WATTS BAR NUCLEAR PLANT (WBN) - RESPONSE TO NRC CIVIL INTEGRATED DESIGN
INSPECTION (IDI) ISSUES (50-390/92-201)

CIVIL INTEGRATED DESIGN INSPECTION GENERAL COMMENTS

NRC Civil IDI

50-390/92-201

Response Spectra for Watts Bar Vert (v) direction 2% damping

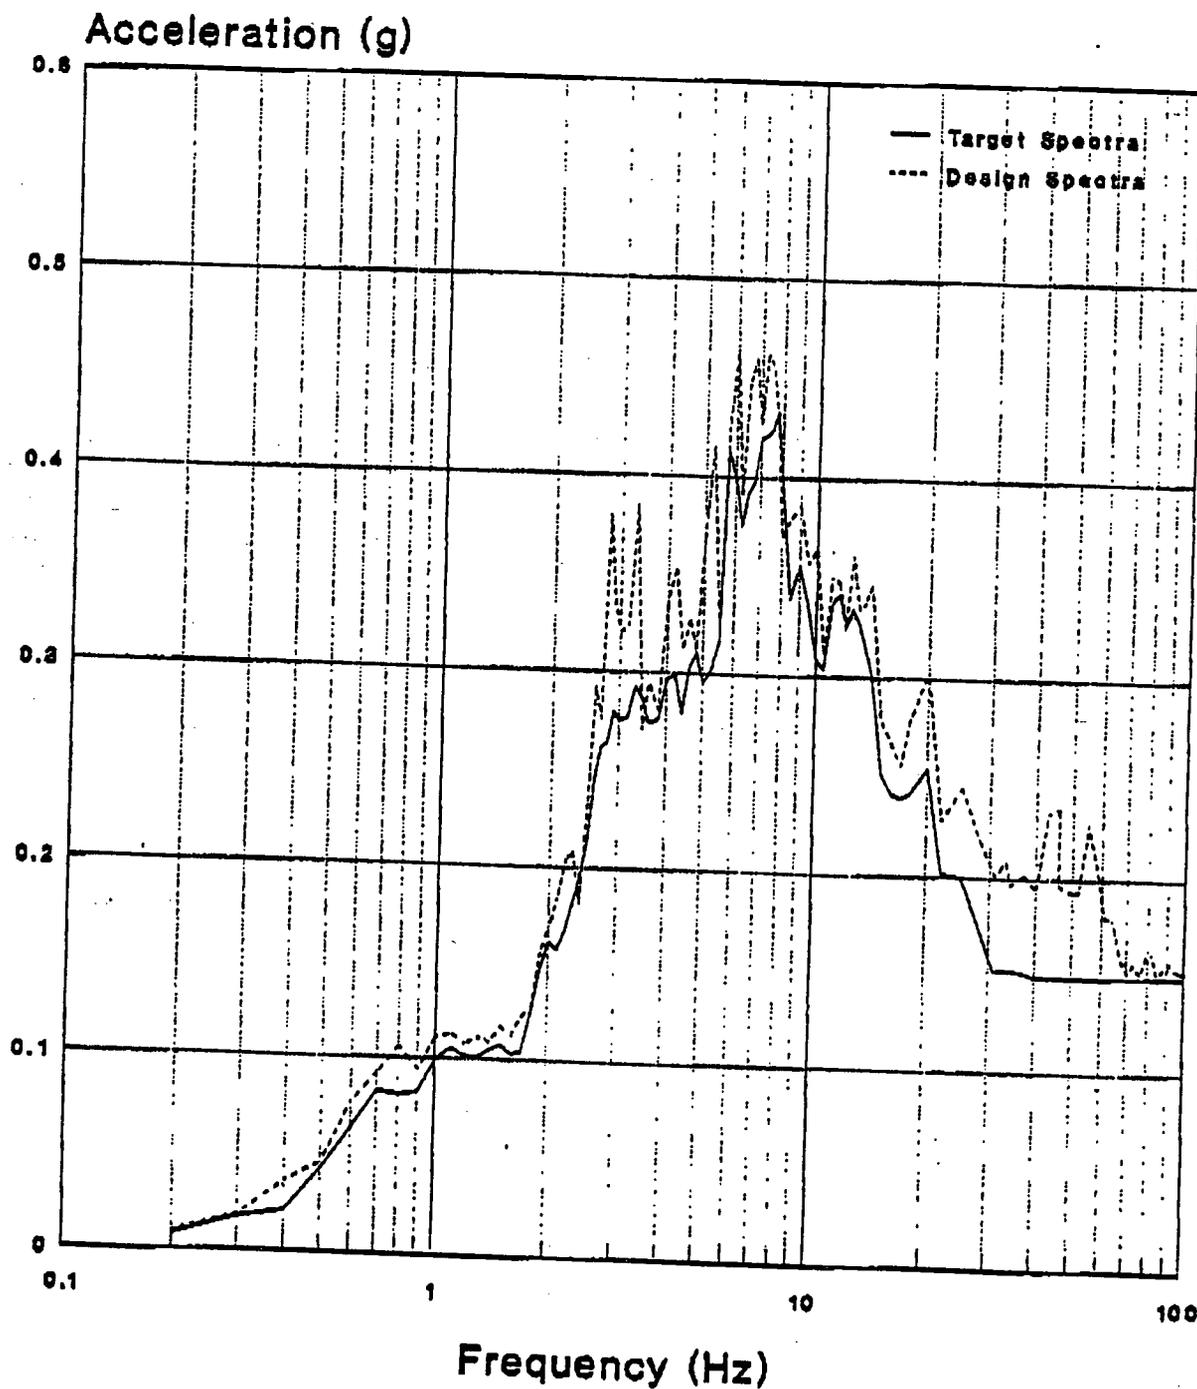
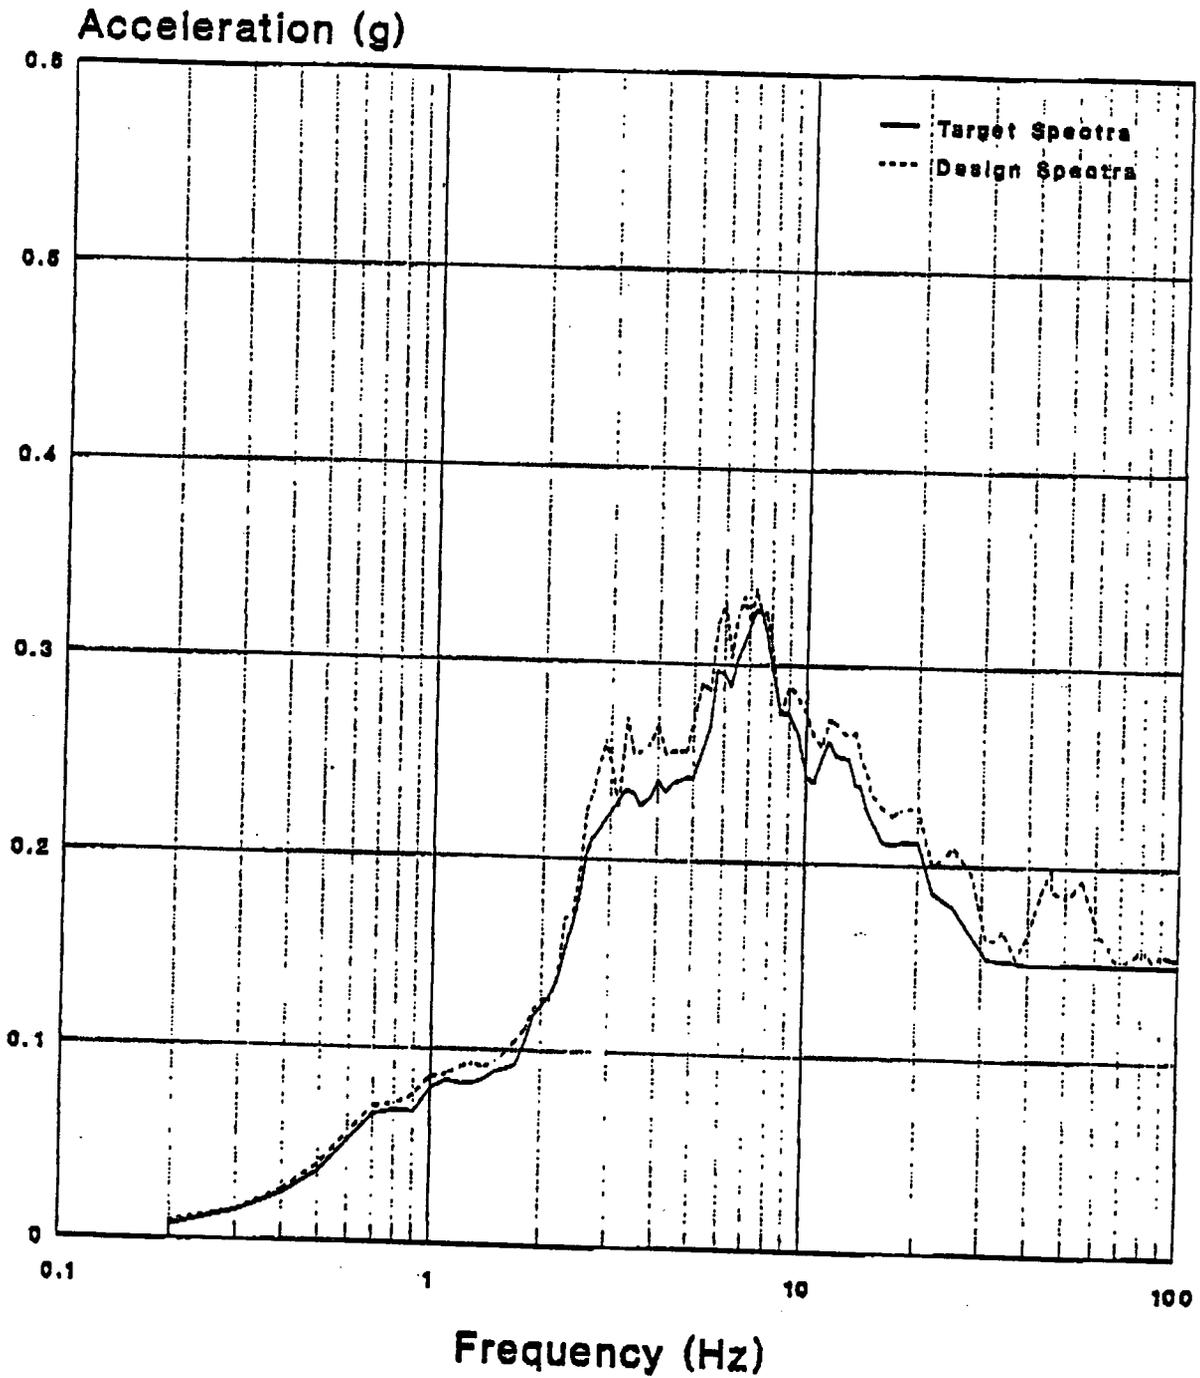
TVA Calculation WCG-1-1238 evaluates 55 HVAC duct supports located at Elevation 729' of the control building. The calculation used zero period acceleration (ZPA) to compute the seismic loads when the fundamental frequency of the supports were 33 Hz or higher. The amplified response spectra (ARS) for the control building, especially in the vertical direction, showed a peak around 48 Hz. The magnitude of the peak was about three times the ZPA value. TVA indicated that they were committed to use ZPA for computing seismic loading for supports having structural frequency higher than 33 Hz as indicated in FSAR 3.7.3.5.1. Further discussion with TVA revealed that the ARS curves were never submitted to the NRC staff for review.

Considering the real time-history records and spectra obtained from these records, the amplification in the vertical spectra at 48-50 Hz for the WBN auxiliary building is an artificial issue and does not reflect any real phenomena. The decision to use the synthetic time-history that was developed as described above was for expediency; the matching below 33 Hz frequency was rather remarkable at four different damping values (comparison at three damping values, 2%, 5%, and 7% are attached) and it was desirable to keep it that way. It is noted that the synthetic time history 2% damping response is about 50% greater than the target response around 50 Hz.

Secondary peaks in the ARS beyond 33 Hz do not reflect the behavior of structures under earthquake loads. These peaks are generated by the numerical difficulties that are encountered in generating the synthetic time-histories. Thus, such peaks should not be used in design; use of the ZPA as indicated by the ARS at 33 Hz (or lower) is adequate.

SUBJECT CALCULATIONS FOR UNIQUE EMB. # 48W930-A-107

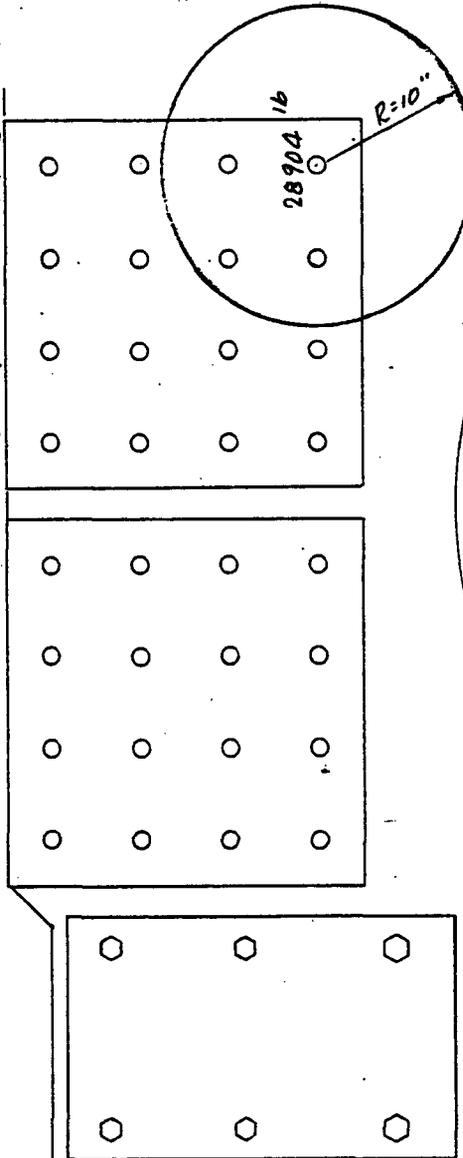
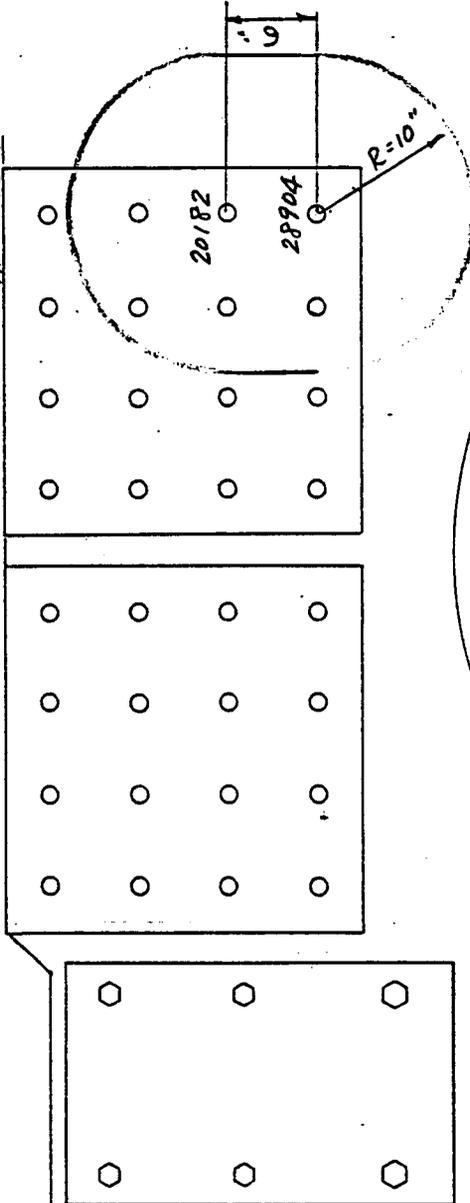
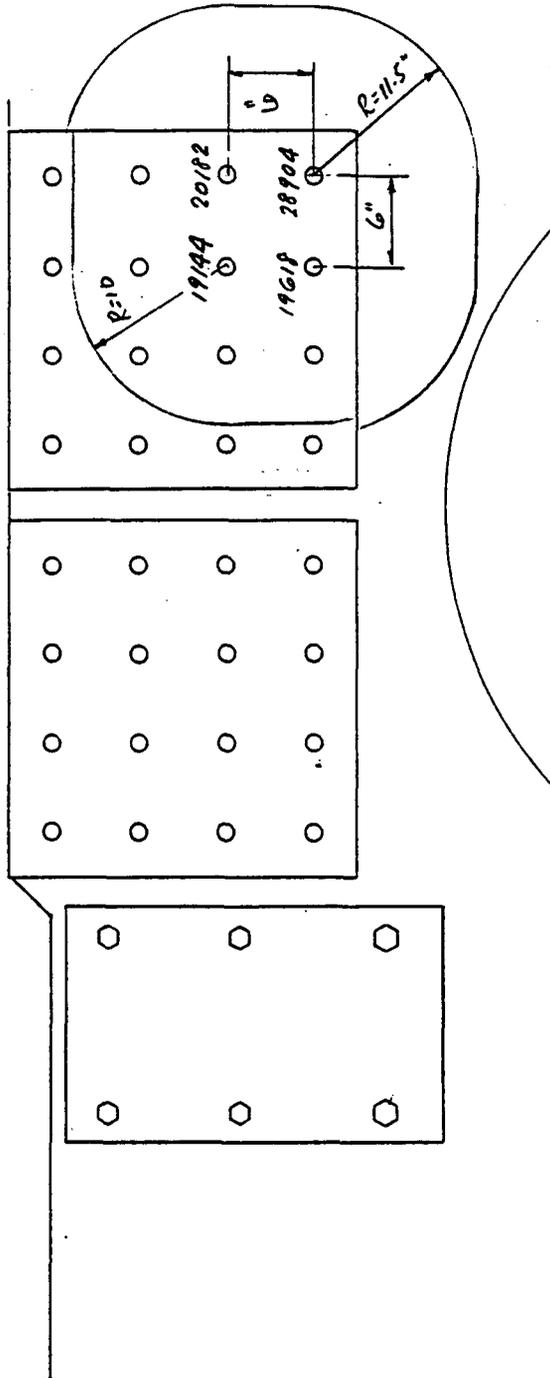
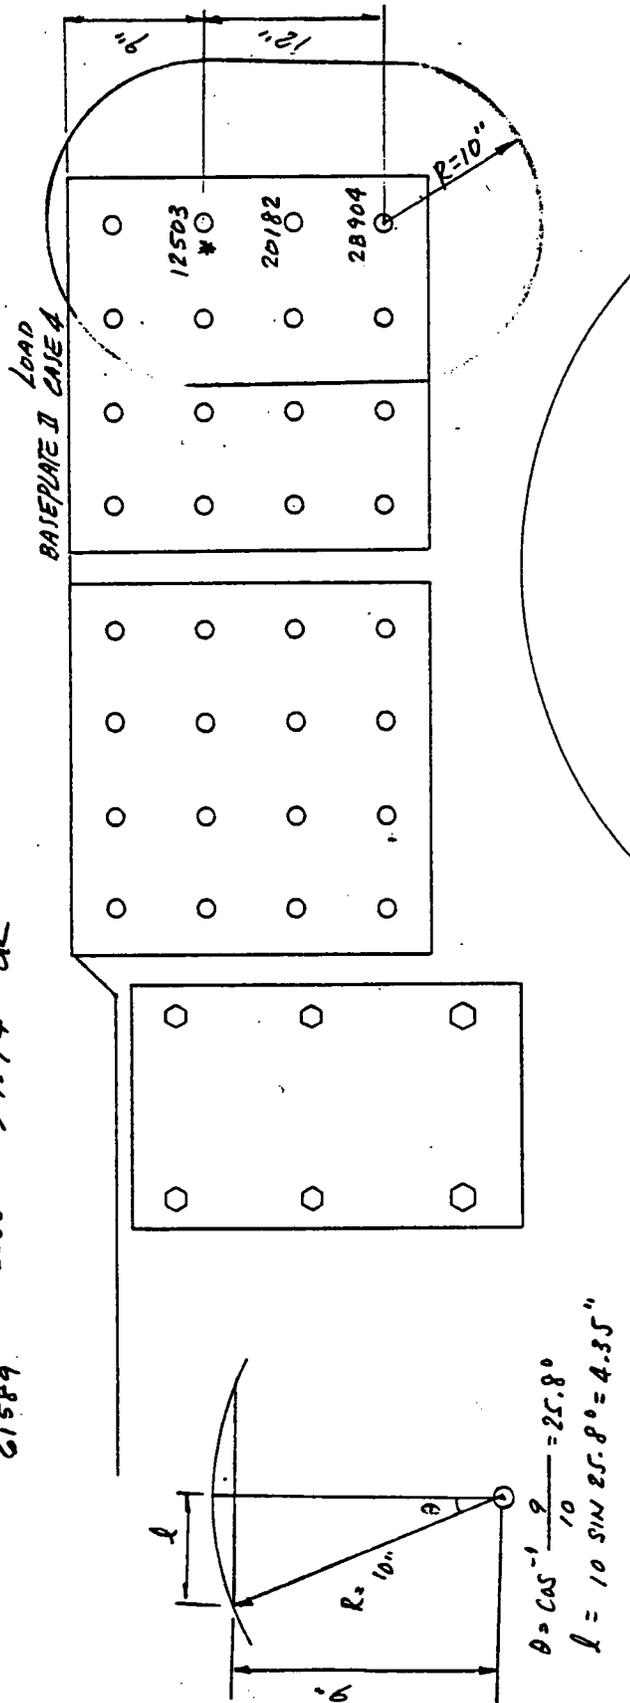
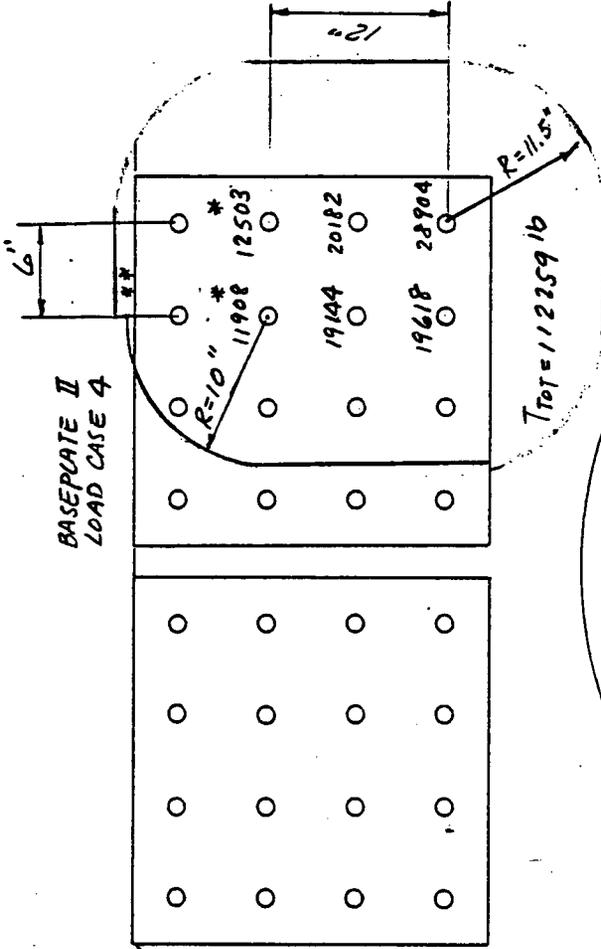
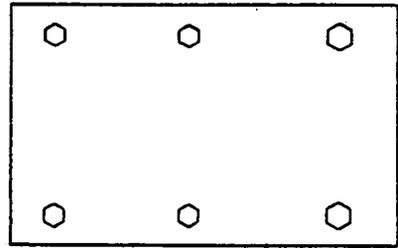
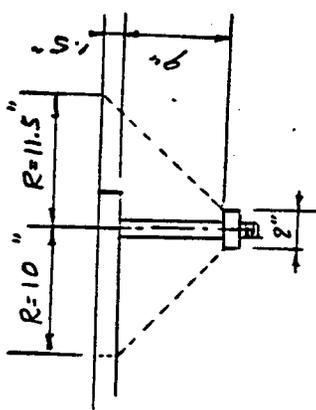
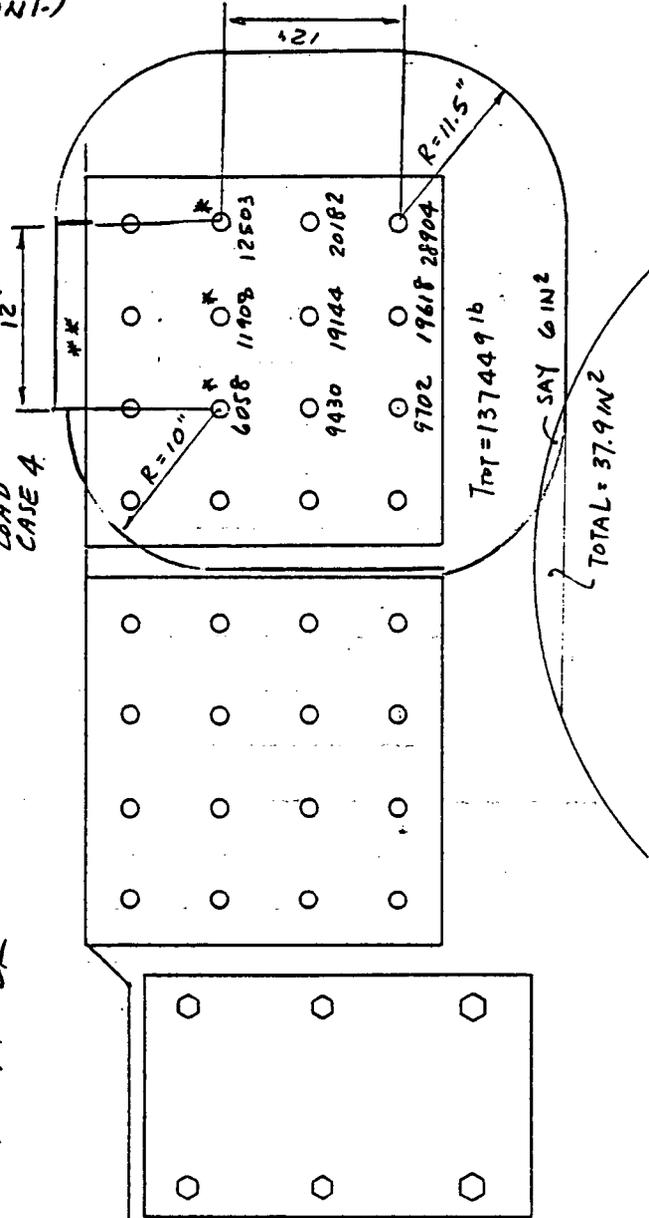
During the inspection, TVA provided sample evaluations of three anchor groups using CONAN. These three groups had two, three and four anchors, respectively. The factor of safety for the most heavily loaded anchor against pullout from concrete in each group was 2.34, 2.16, and 2.00, respectively. The team noted that the factor of safety decreased with increasing number of anchors. Since there were 16 anchors each in plates 2 and 3, it was conceivable that, when the CONAN code was applied to these plates, the factor of safety for the anchor in question might be less than the required minimum factor of 1.94. The value 1.94 was derived by dividing the required factor of safety for embedded plate with the faulted load factor, i.e., $3.1 + 1.6 = 1.94$.

F.S. = $\frac{221669}{112259} = 1.97 > 1.94 \text{ -OK}$
